PELICAN™ 1300 PROTECTOR CASE™

TECH BULLETIN | 11/01/2022

GEN 2 NOW AVAILABLE

1300

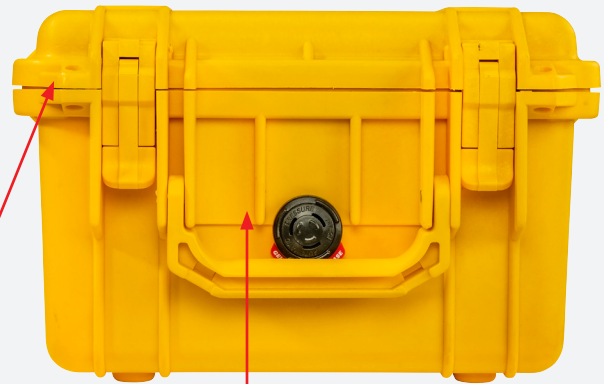
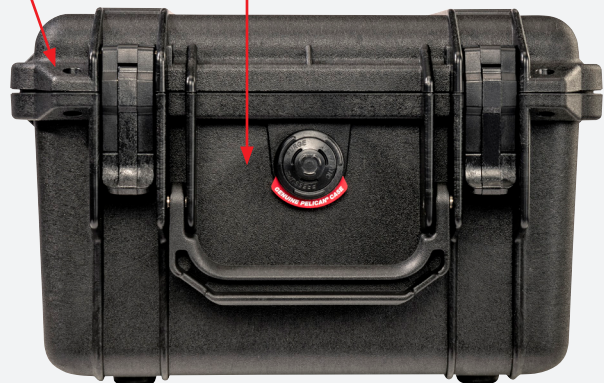
- » External Ribbing Removed On Front
- » Re-positioned PRV
- » Excess Material Removed From Padlock Areas
- » Excess Material Removed From Inside Wall
- » Exterior Dimensional Differences
- » Interior Dimensional Differences

INTERIOR LENGTH			INTERIOR WIDTH		
	GEN 1	GEN 2	DIFFERENCE	GEN 1	GEN 2	DIFFERENCE
BASE	9.510"	9.528"	+0.018"	7.322"	7.321"	+0.001"
LID	9.284"	9.525"	+0.241"	7.21"	7.312"	+0.102"
